FIELD REVISION #1 AS OUTLINED (4/14/17) 1. SANITARY SEWER STRUCTURE TOPS REVISED TO MATCH NEW GRADING. 2. SEPARATION REVISED AT STORM/SANITARY CROSSING TO REFLECT CHANGE IN

10 - 31 - 2017SANITARY SEWER DETAILS & PROFILES

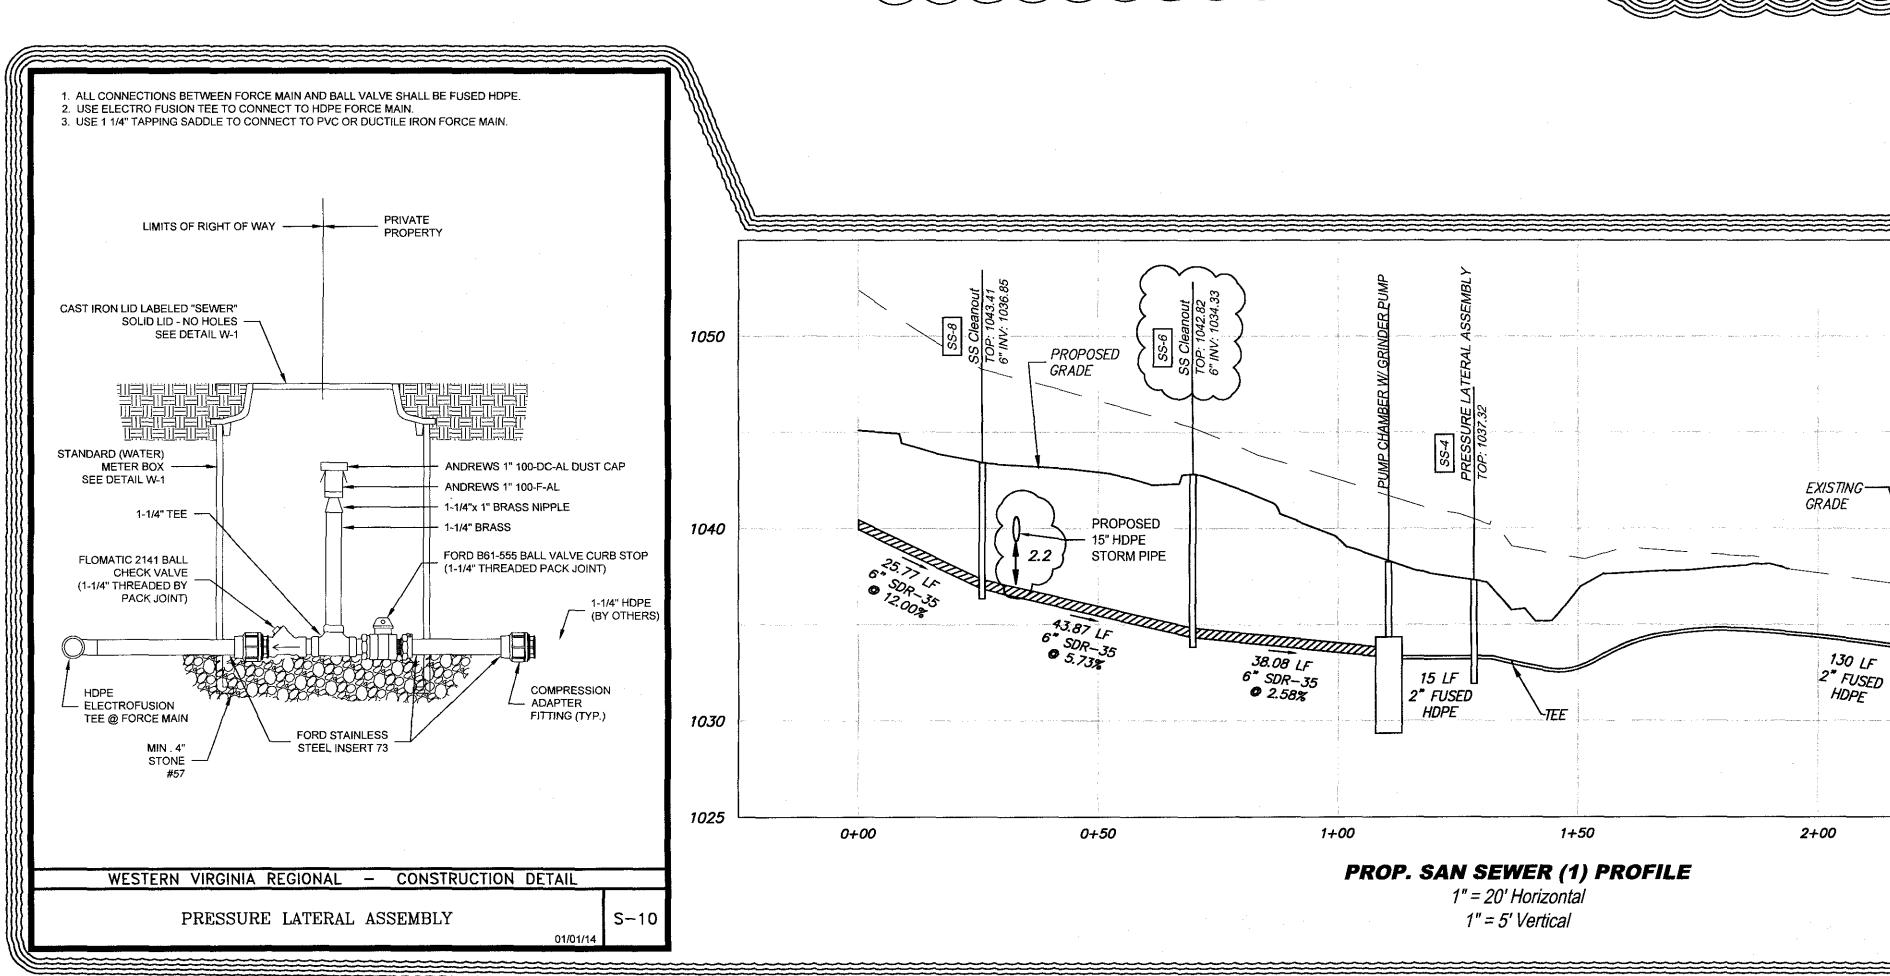
FIELD REVISION #4 AS OUTLINED (10/131/17): 1. SANITARY DETAIL DRAWING FOR PRESSURE LATERAL ASSEMBLY (S-10) ADDED.

STORM SYSTEM ELEVATIONS.
